THE STAR- MODIFICATION 13 LANDSCAPE DESIGN REPORT

PREPARED FOR THE STAR
20.03.2018
REV.B 30.01.19

The Star Modification 13 - Landscape Design

Response to Letter received from Alex Greenwich and the City of Sydney Submission

Tree Retention strategy

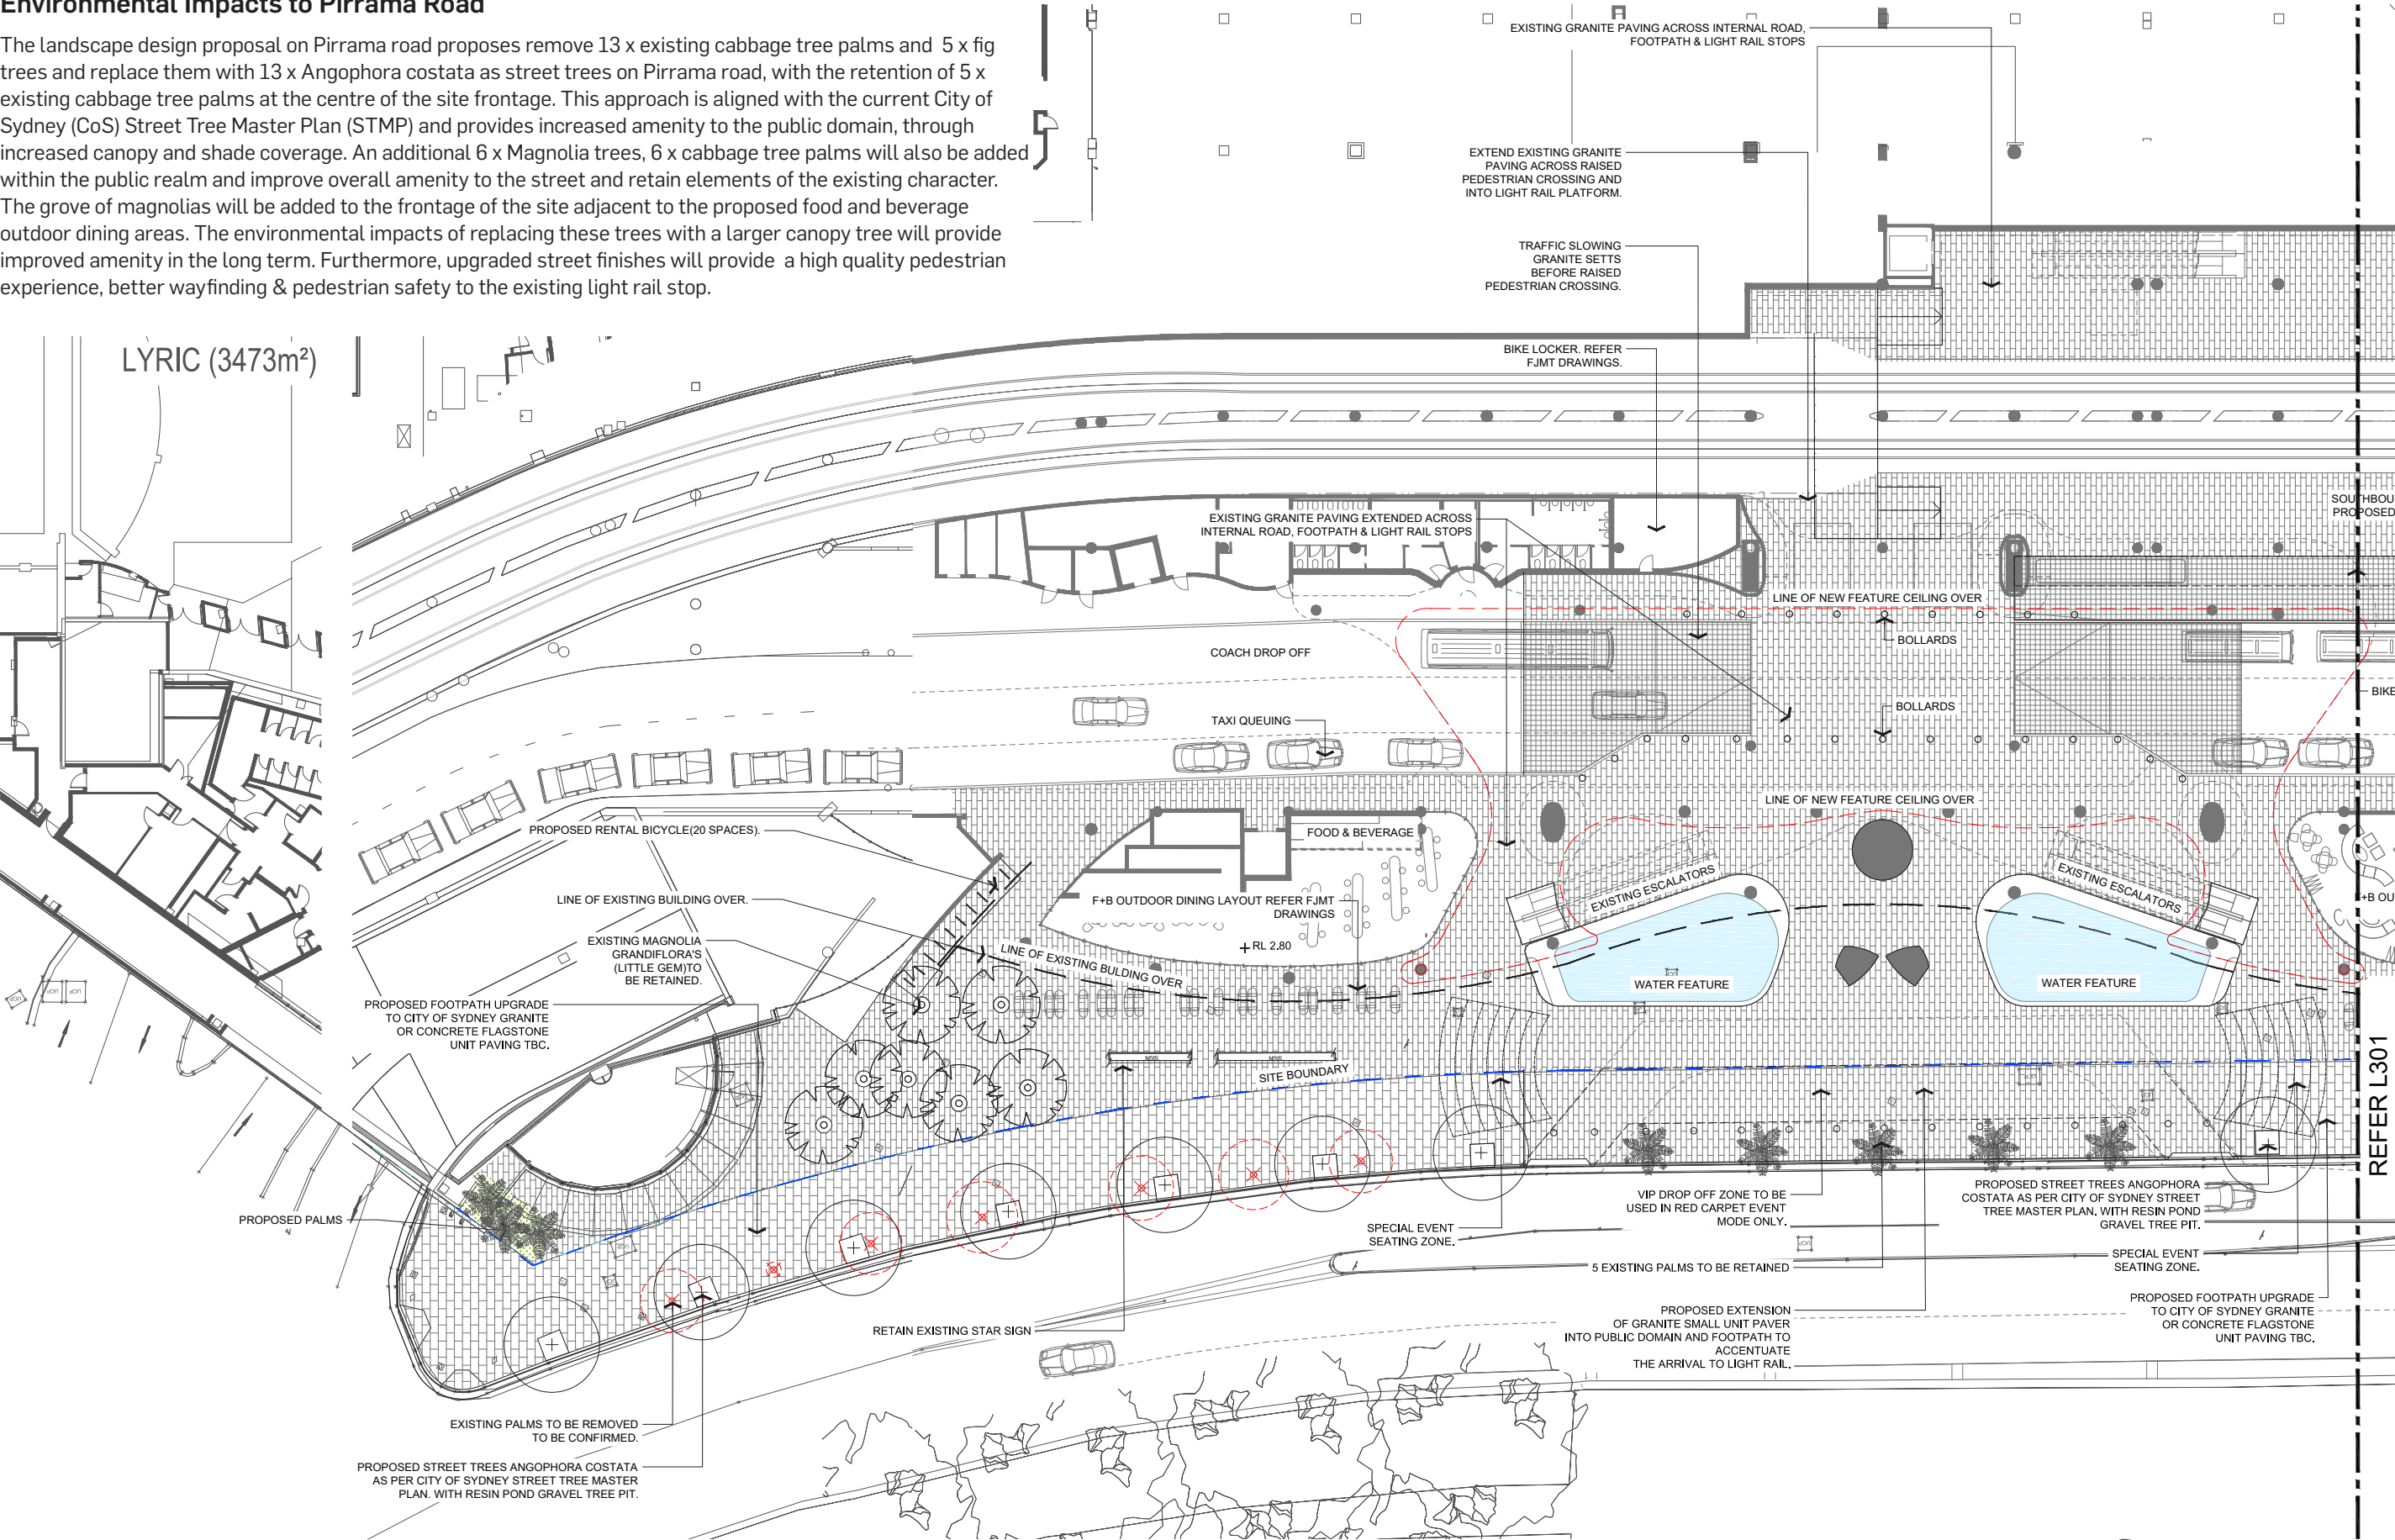
The development would result in the loss of 24 trees including 16 of high retention value, to be replaced with 24 trees of various species. This represents the absolute bare minimum that could be done; no attempt has been made to increase the net number of trees, to ensure there is no loss of tree canopy or to replace trees with mature plants. This proposal shows contempt for community efforts to increase greenery and for NSW Government and City of Sydney plans to increase green cover to address increasing temperatures and heat sink effects.

An arboricultural assessment of seventy-two (72) trees located in the vicinity of The Star Casino and Entertainment Complex, located at 80 Pyrmont Road, Pyrmont was prepared. The purpose of the report was to assess the potential impact of works proposed under the Modification 13 Application on existing trees surrounding the proposed development.

The proposed development will necessitate the removal of four (4) trees of low and very low retention value, four (4) of moderate retention value and sixteen (16) trees of high retention value. The trees of low and moderate value can be replaced with new tree planting in the short term (next 10 to 15 years). As such, there will be a relatively minor and temporary loss of amenity resulting from the removal of these trees to accommodate the proposed development.

The trees of high retention value have no special heritage or ecological significance, but they are mature specimens that make a positive contribution to the amenity of the site and streetscape areas. There are no feasible options that can be implemented that would permit the retention of these trees given the design intent. Replacement planting is proposed to compensate for loss of amenity in streetscape areas in accordance with the City of Sydney Council's Street Tree Master Plan. The sixteen (16) trees of high retention value that will be removed include twelve (12) Cabbage Tree Palms and four (4) Hill's Weeping Figs, all located on the Pirrama Road frontage. The proposed replacement trees *Angophora costata* are as per the City of Sydney Tree Master Plan they will increase the amenity to pedestrians using this area, in particular increased shade to paved areas. The replacement trees will be specified as mature plants.

Tree Protection Measures and a Tree Protection Plan will ensure the remaining trees surrounding The Star are retained and protected during construction.

LEVEL 6 - NATIVE GREEN ROOF

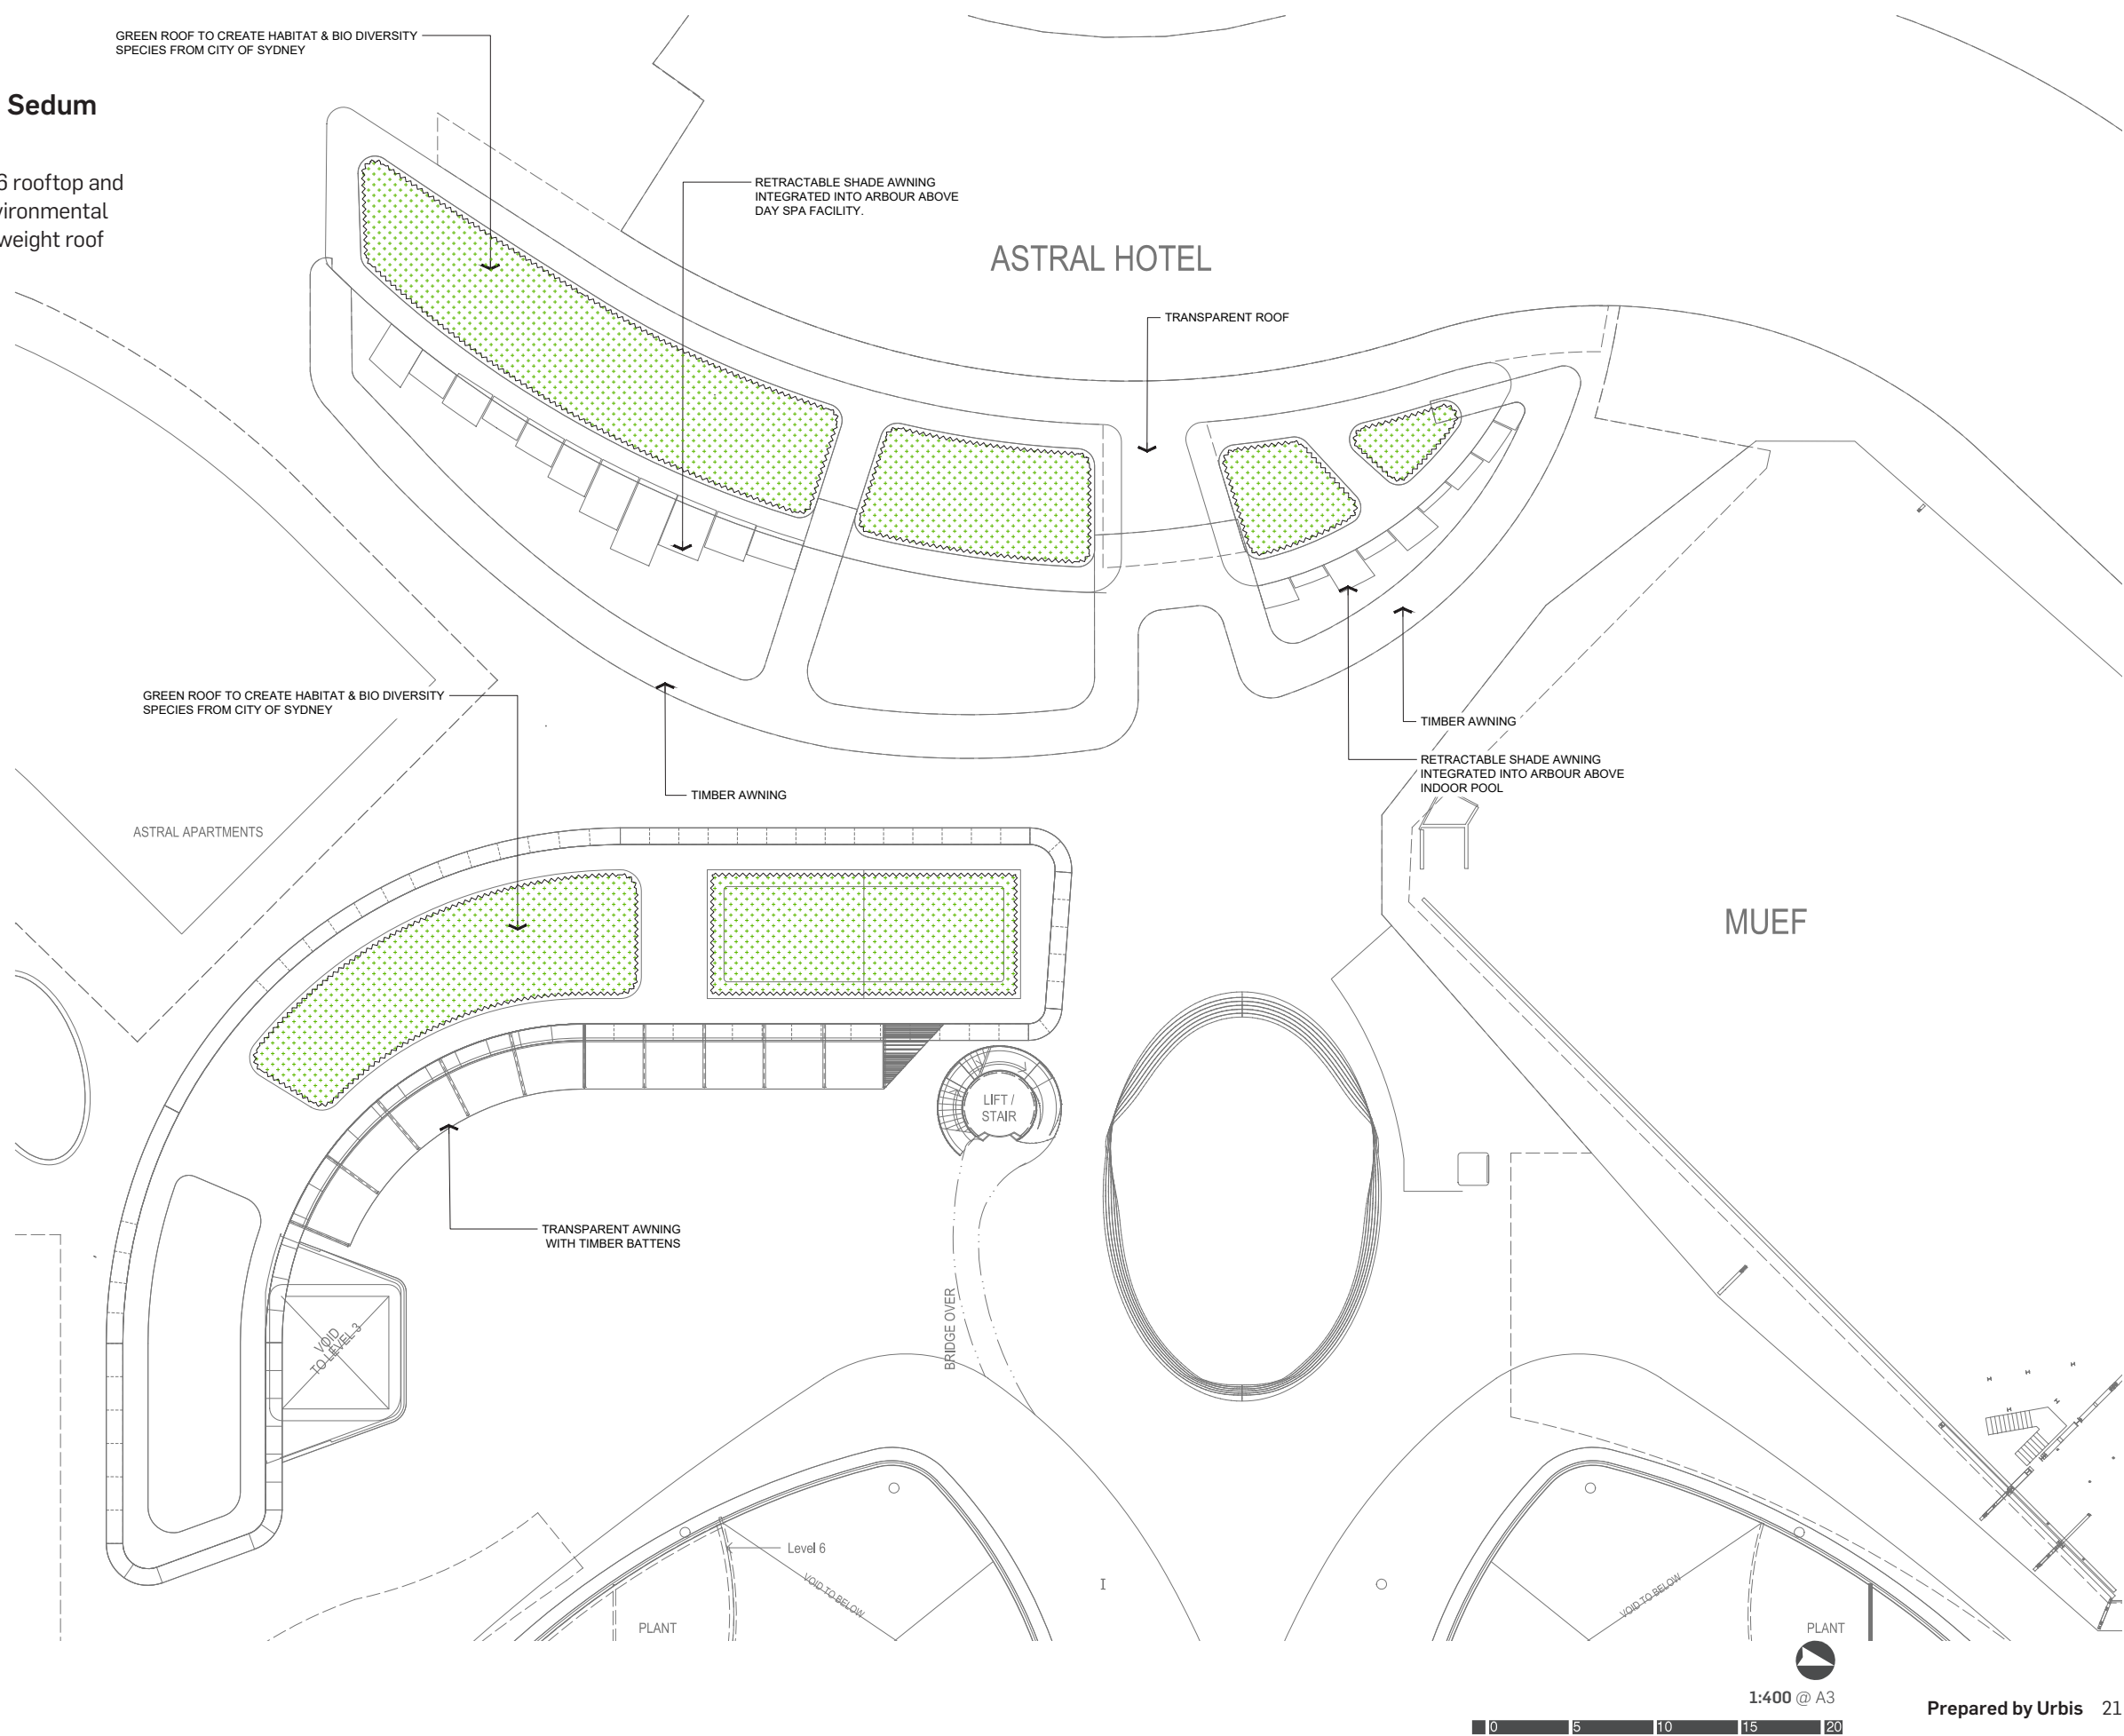
Again, there is insufficient detail provided to enable a full and proper assessment.

- b) To improve the biodiversity value of the proposed green roofs, consider replacing or supplementing the planting of sedum with native species mix / biodiverse wildflower planting*

Urbis have developed a planting design for the green roof to create habitat and biodiversity, the plant schedule and detail was developed with City of Sydney (and is consistent with the Mod 14 submission). Refer to Appendix A for plans and section details of the Green Roof.

Urbis has replaced the sedum rooftops with a native species mix / biodiverse wildflower planting as per Mod 14 (species co-ordinated with City of Sydney). Additional native plants have also been added to the plant schedule.

ROOF TOP - CLUB LOUNGE

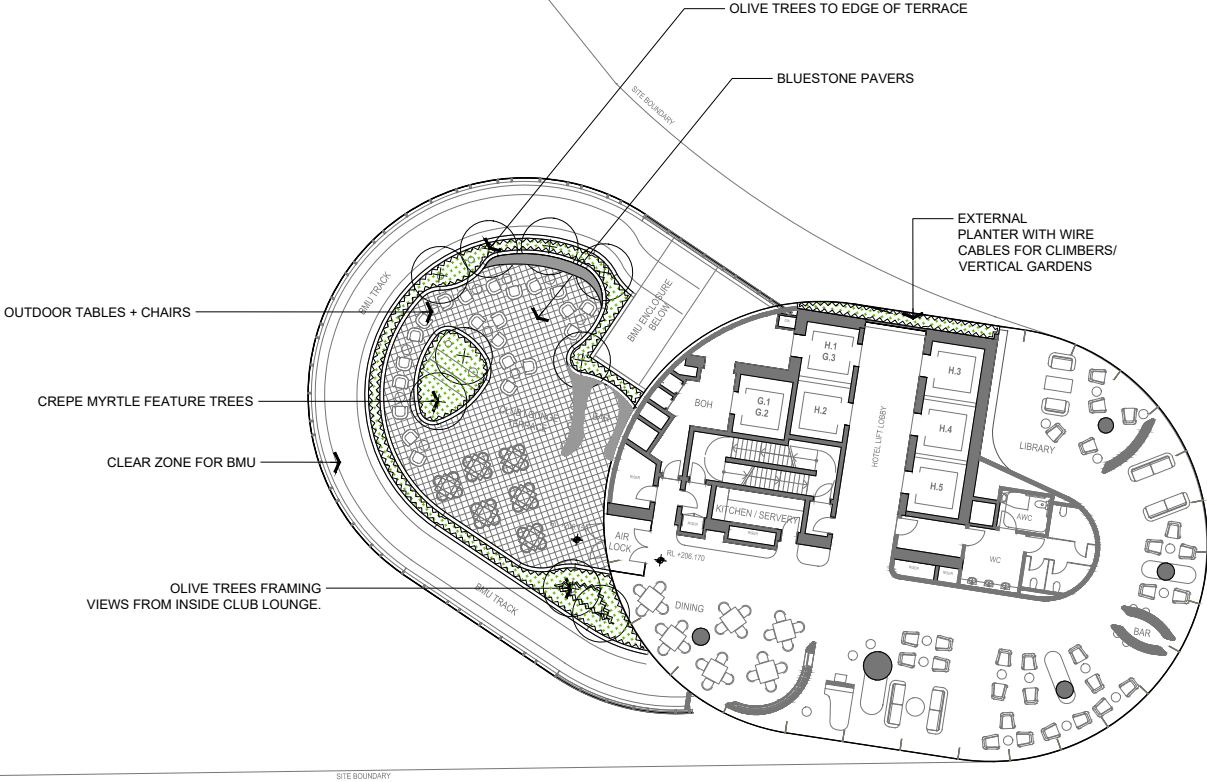
•The Level 59 Club Lounge description does not match the plans. There is no wind study evidence to confirm that the landscaping proposed has been designed to withstand the western aspect and likely wind effects. Is the proposal achievable at upper levels of the tower?
